Kangaroo Bay Hotel – Major Project Permit

78 Cambridge Road, Bellerive

Prepared for
Clarence City Council

Our reference
24938T-REP01

Figure 4-3: Right of Way Easements on the Site

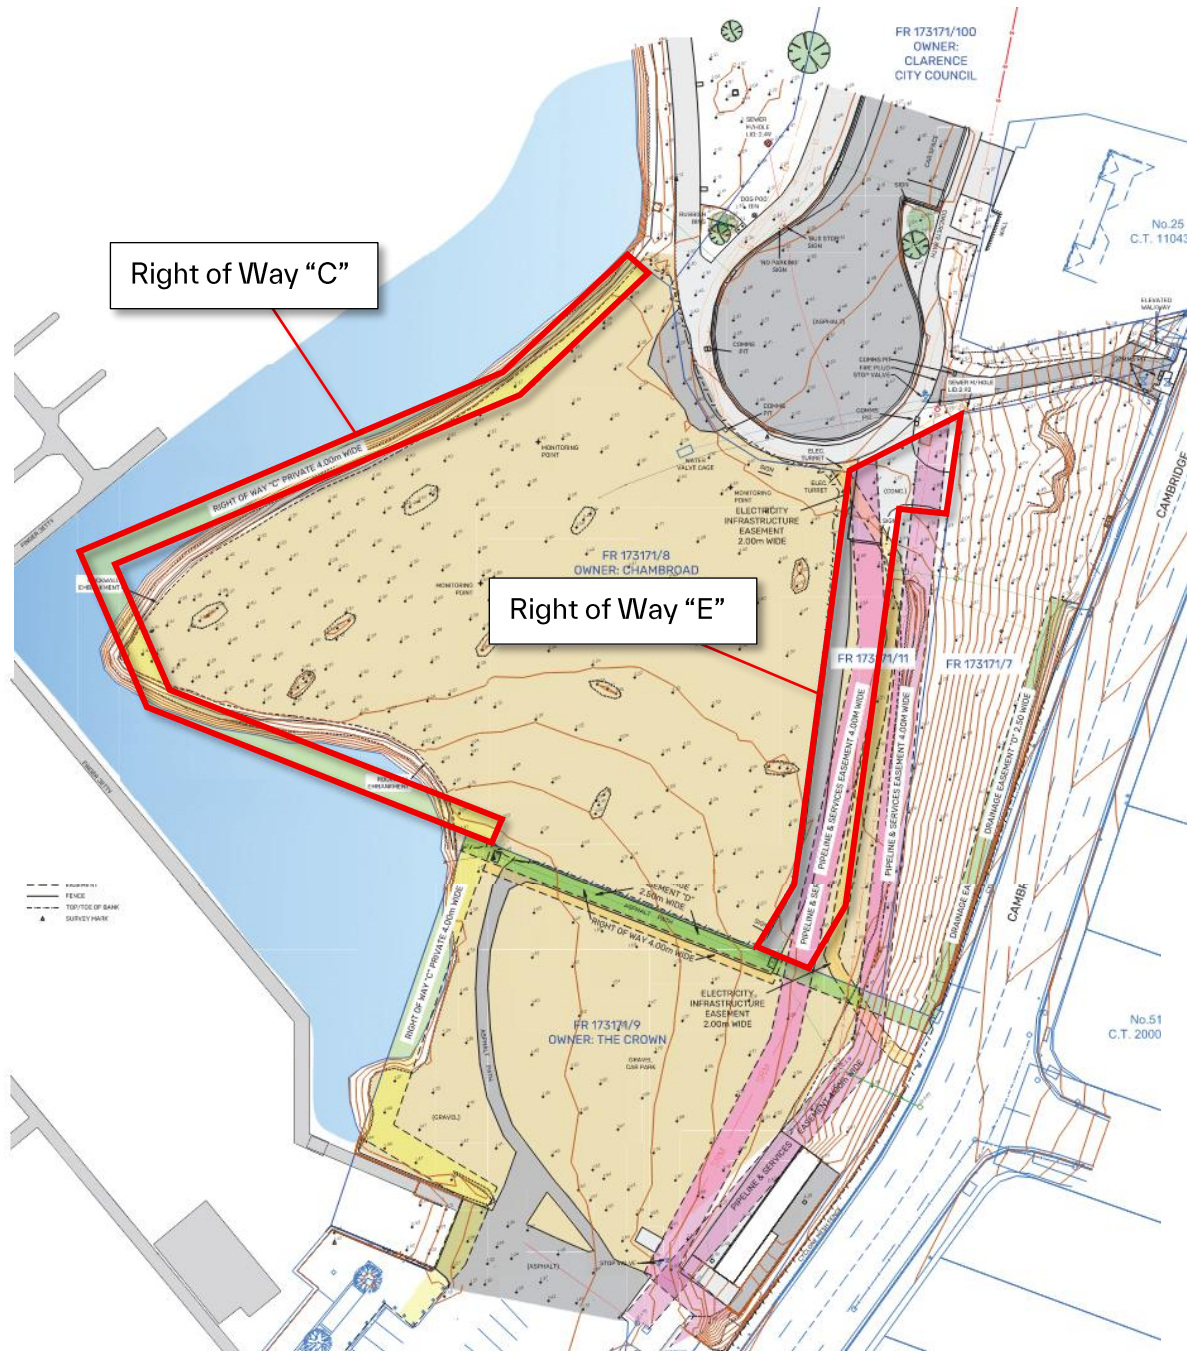
99. As described in **Section 4.1** of this statement, the Site is subject to a number of easements. The following discussion relates to Right of Way “E” which is located on Lot 11 (CT 173171/11) and is shown on Figure 4-3.

100. Right of Way “E” has a width of 8.0 metres offset from the western boundary between Lot 8 and Lot 11 within the Site, except for the northern end of the Right of Way near Kangaroo Bay Drive which is widened to provide access to Lot 7.

Figure 4-4: Proposed Ground Floor Plan

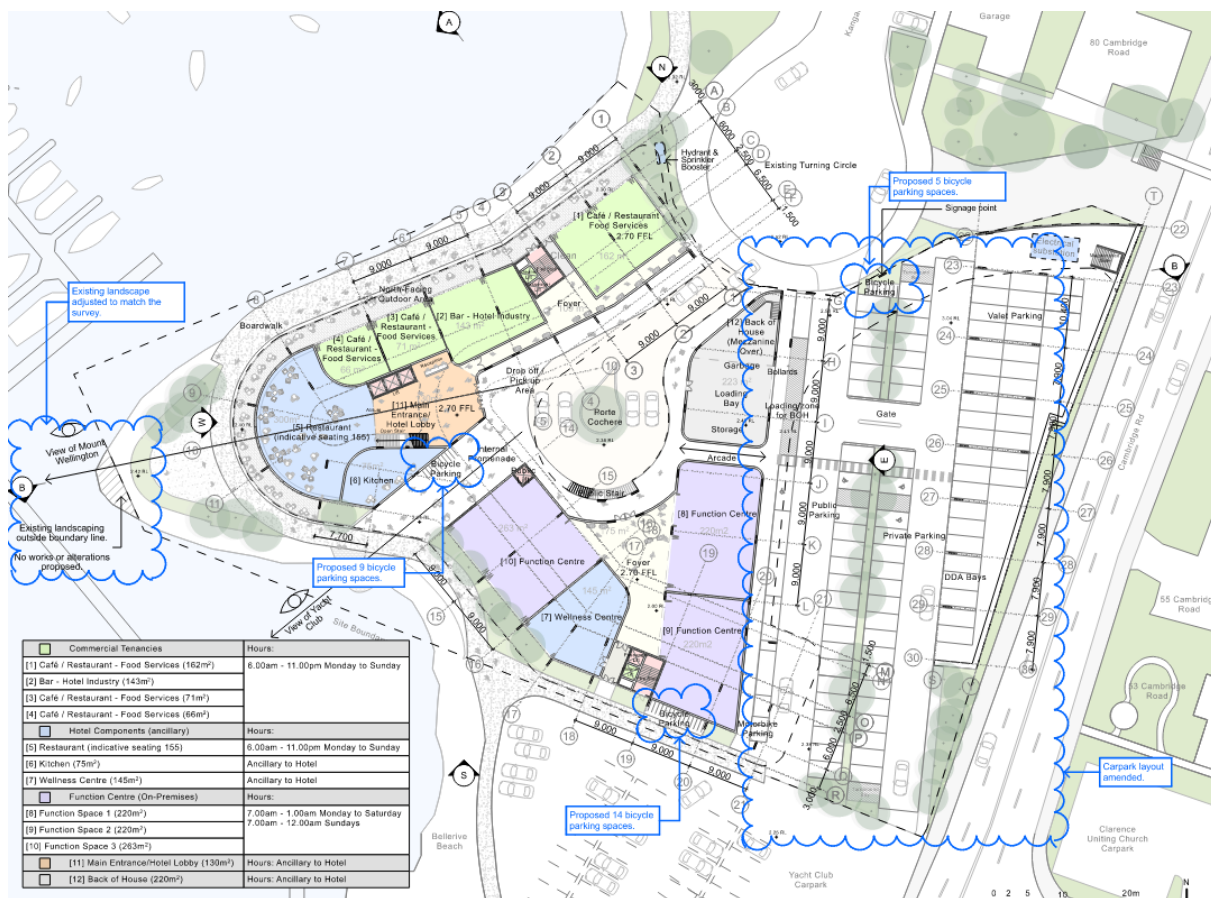
112. I note that the updated Ground Floor plan contained within the Chambroad Representation (Vigilus Dwg No. A.02 Ground, Rev Q dated 29/06/2026) appears to show columns encroaching parking spaces and the parking aisle. Further coordination of the structural design would be required to ensure adequate clearance to columns and other vertical obstructions.

Figure 4-5: Approved Car Parking Plan – D-2018/469

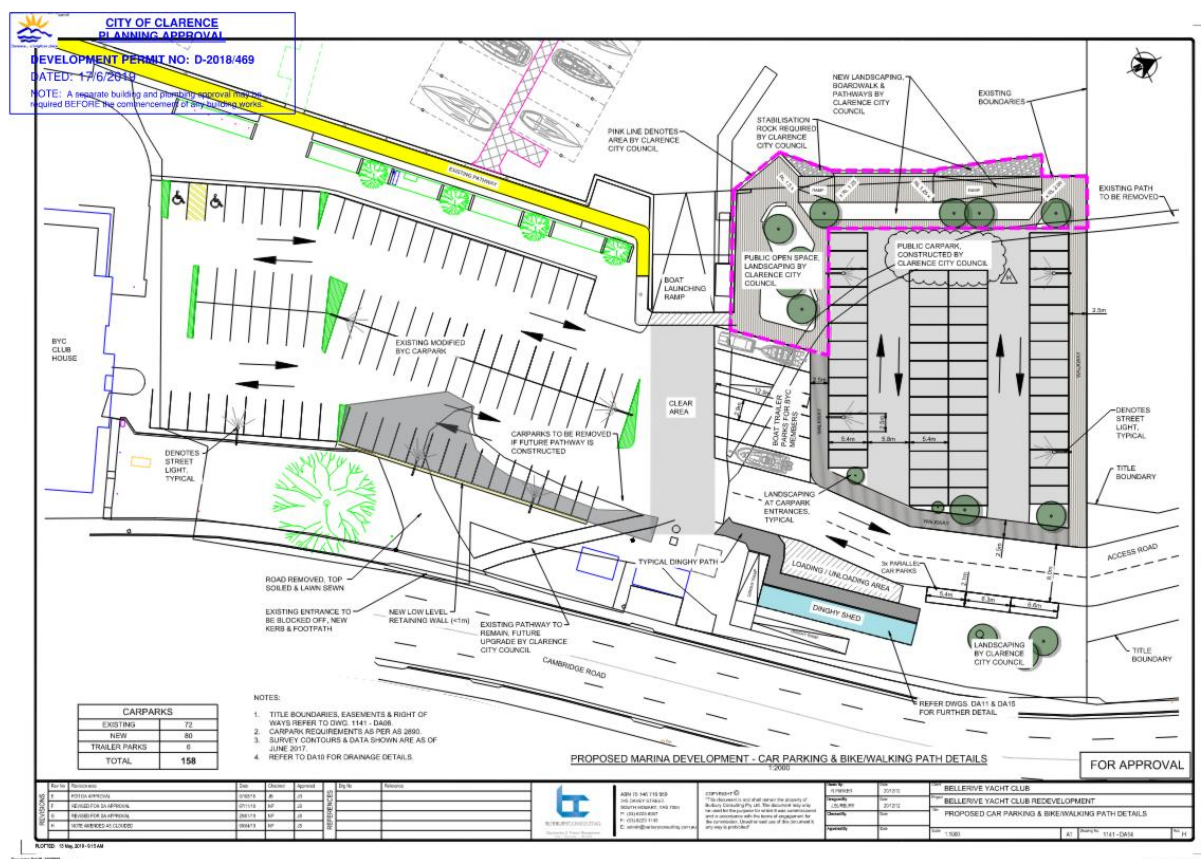
88. It is noted that the second alternative would only be available in the interim period, prior to the planned closure of this access point as approved under Permit No. D-2018/469 (refer Figure 4-5).

Figure 6-2: Landscape Plan - Carpark

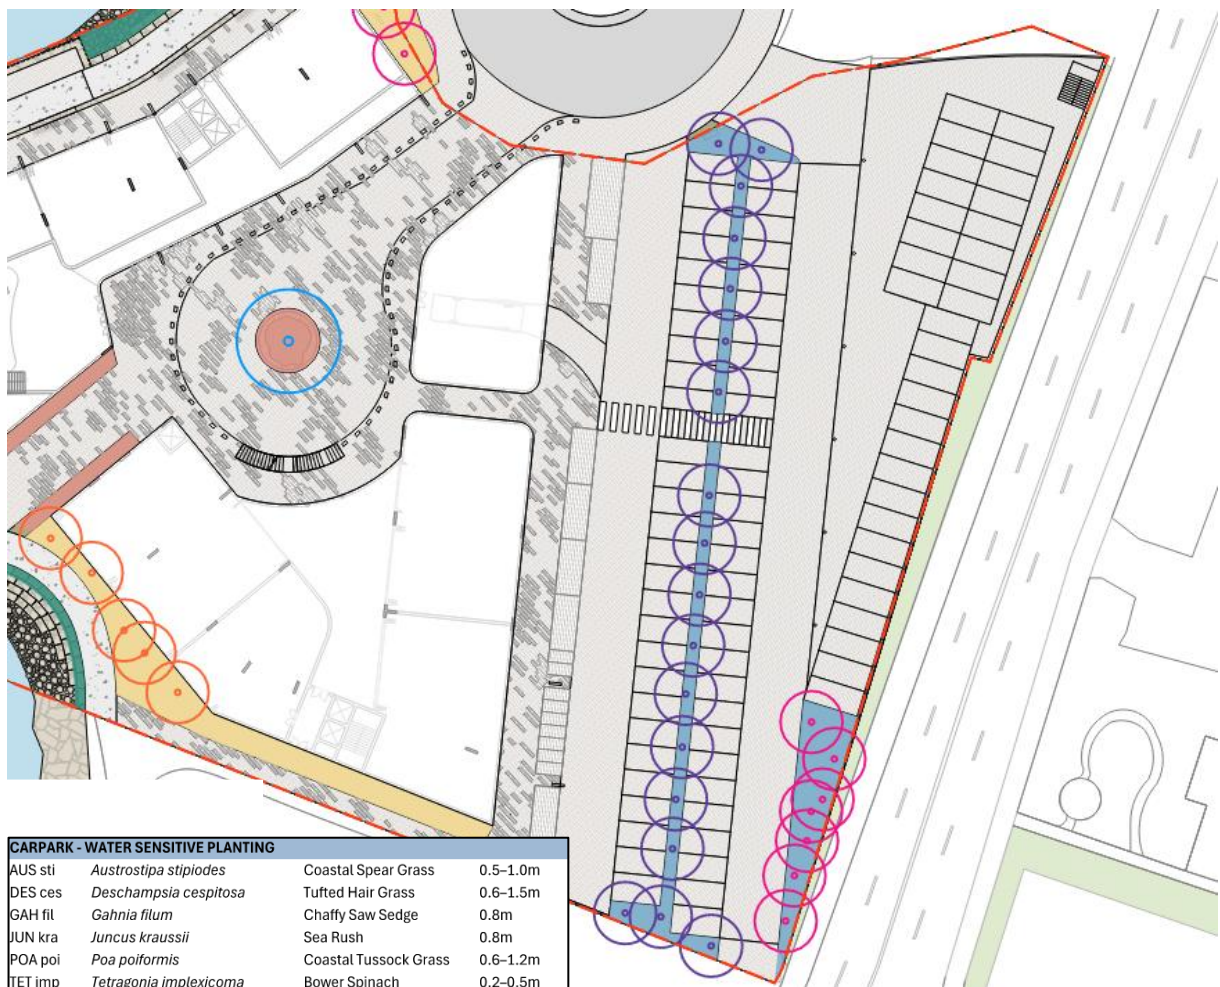
- a. The landscape architecture plan prepared by Realm Studios shows tree planting within this area, along with a range of other grasses and shrubs having typical heights of up to 1.5 metres. Any planting greater than 0.15 metres in height in this area would obstruct the ability for vehicles to overhang (refer Figure 6-2).

Figure 6-3: Concept Stormwater Design – Carpark

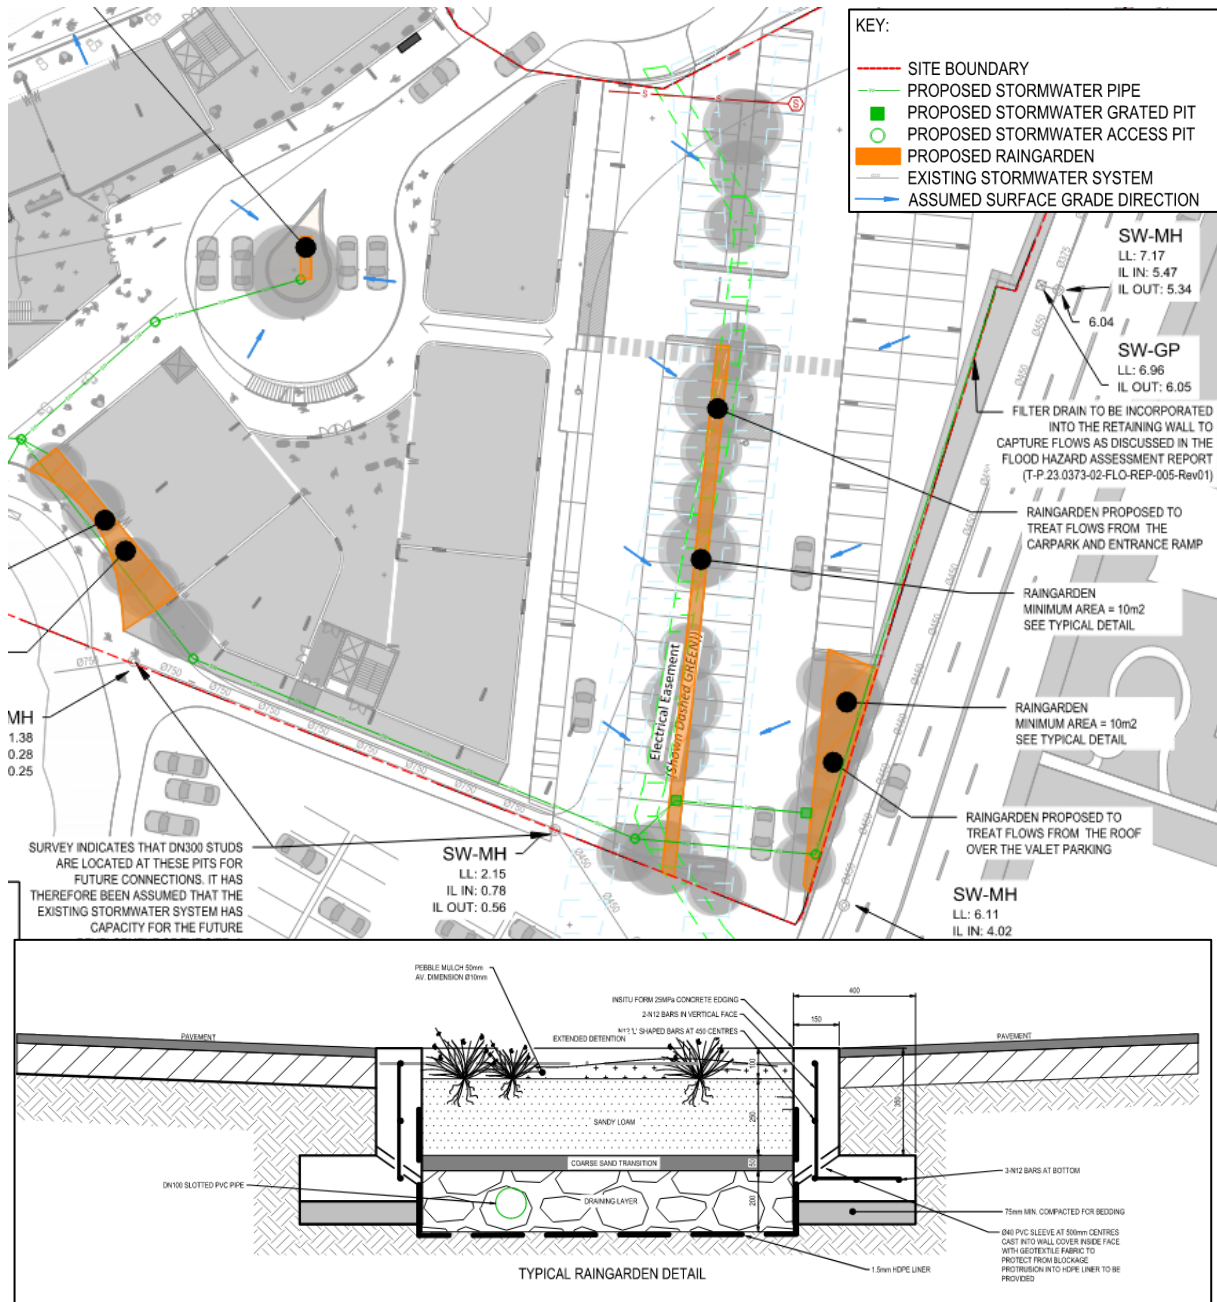
- b. The Concept Stormwater Design prepared by pitt&sherry shows this part of the carpark as being a Proposed Raingarden, and integral to the stormwater treatment strategy for the Site. The Typical Raingarden Detail excludes kerbs and it is unclear whether the inclusion of kerbs or wheelstops (as required to prevent encroachment) would impact the effectiveness of the raingarden (refer Figure 6-3).

Figure 8-5: Shared Path with Vertical Obstructions Either Side

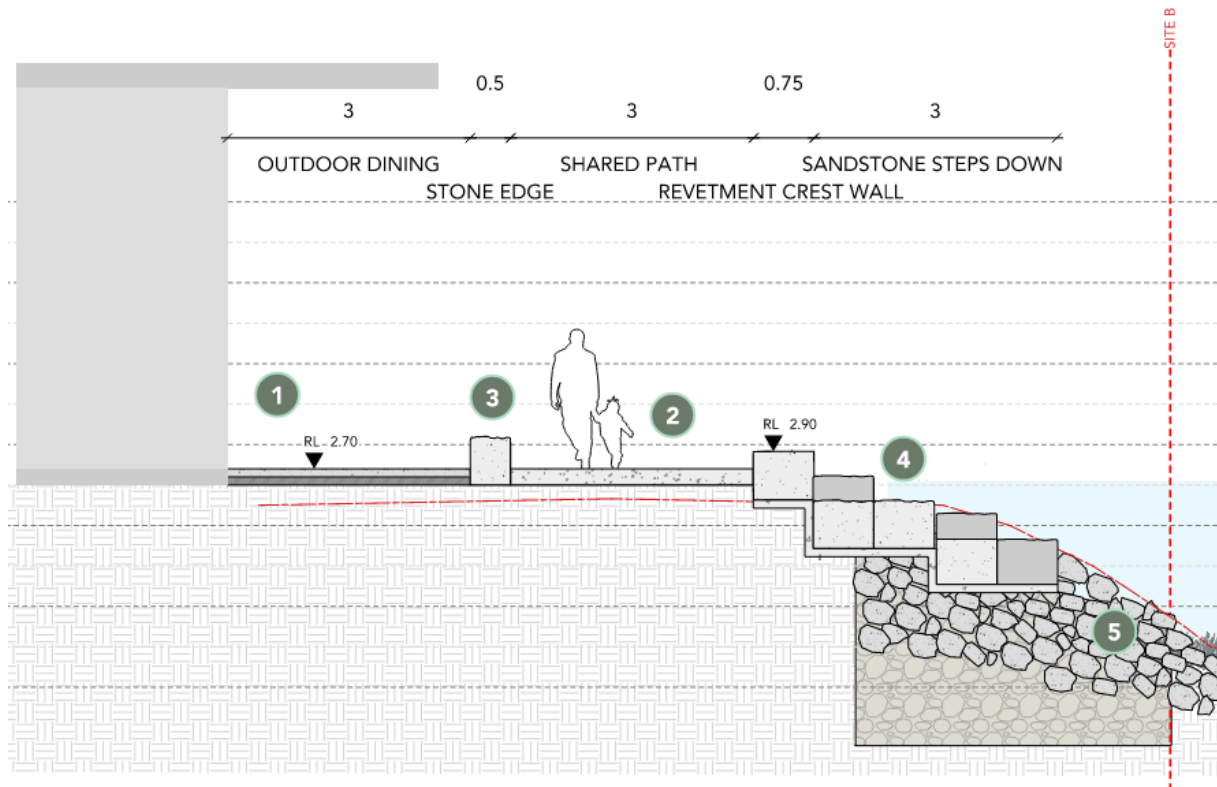
205. The Project includes an extension of the Clarence Foreshore Trail through the Site along the western edge of the development. It is understood that it would comprise a 3.0 metre wide exposed aggregate, concrete path with stone edging to separate it from the adjacent outdoor dining area. An additional boardwalk with seating, viewing platform and other public spaces would be provided on the water side of the path⁵.
206. A review of the Landscape Section Details provided with the MPIS shows that separators either side of the shared user path may constitute a vertical obstruction requiring clearance as set out in Austroads Part 6A. These separators would need to be tall enough to prevent from being a tripping hazard, and would therefore be in an area that may be clipped by pedals and/or handlebars. The stone edges would be rough.
207. Refer to Figure 8-5 below.

208. The proposed shared path width should be increased to 4.0 metres, in line with the minimum width design standards provided in Paragraph 204 above. This will provide sufficient clearance for cyclists to safely pass each other, or for a cyclist to pass a pedestrian or a group of pedestrians, without undue risk of conflict with obstructions either side. A width of 4.0 metres is also consistent with the width of Right of Way “C” as recorded on the title.
